ED-HMI3120-133C

PCN

by EDA Technology Co., Ltd

1 Product Change Notice 1

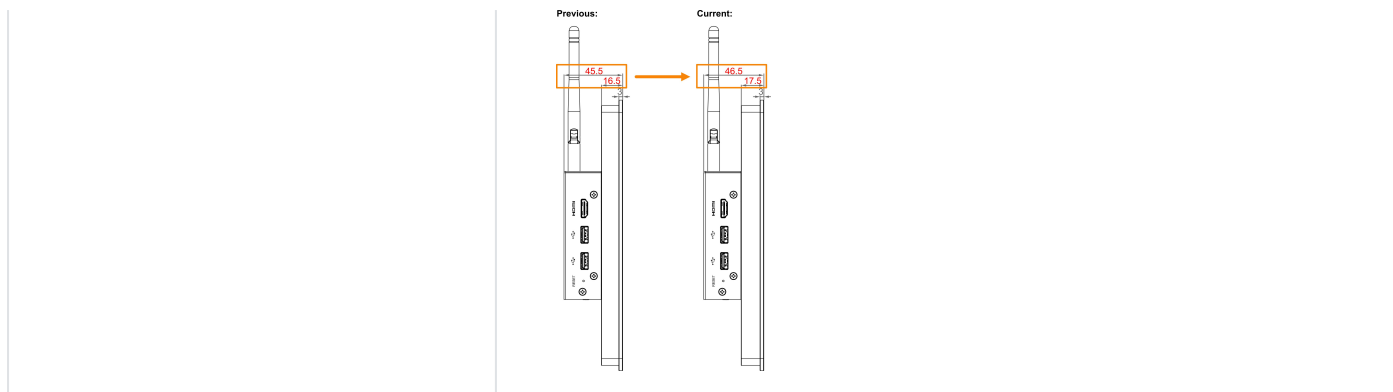
Changes	Results
LCD bezel thickness increased by 1mm	We have optimized the LCD bezel structure to provide additional clearance for internal cable routing. - LCD bezel thickness: adjusted from 16.5mm to 17.5mm. - Total product thickness: correspondingly adjusted from 45.5mm to 46.5mm.
